Access Compliance Report

Public Rights-of-Way

(Pedestrian Signals)

Intersection ID: N/A	Main Street:	Cross Street: N/A	Location: N/A
ADA ID: 6912B56AAAE3	Signal Type: Two Push Buttons-APS	Overall Compliance: No	Severity Score: BTN 1:N/A BTN 2: N/A No BTN: N/A
Codes/Mitigation Info/Possible Solution		Field Measurements/Component Compliance

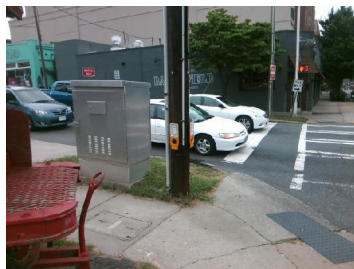
Yes	B 1 Clear Xing Direction?	ClearlyMarked	Yes	B 2 Clear Xing Direction?	ClearlyMarked
	B 1 Crossing Direction	To SE		B 2 Crossing Direction	To SW
Yes	B 1 DistanceTo XWalk (in)	50.0	Yes	B 2 DistanceTo XWalk (in)	0.0
Yes	B 1 DistanceTo Curb (in)	69.0	No	B 2 DistanceTo Curb (in)	90.0
Yes	B 1 Diameter (in)	2.0	Yes	B 2 Diameter (in)	2.0

Possible Solutions: Remove & Replace Replace APS Button With New APS Button. Remove and Replace Clear Space. Replace Signal Push Button With APS Button on New Post. Remove & Relocate Sign.

PROW/ADA: R410.6, R404.2, R404.3, , TMUTCD 4e.08
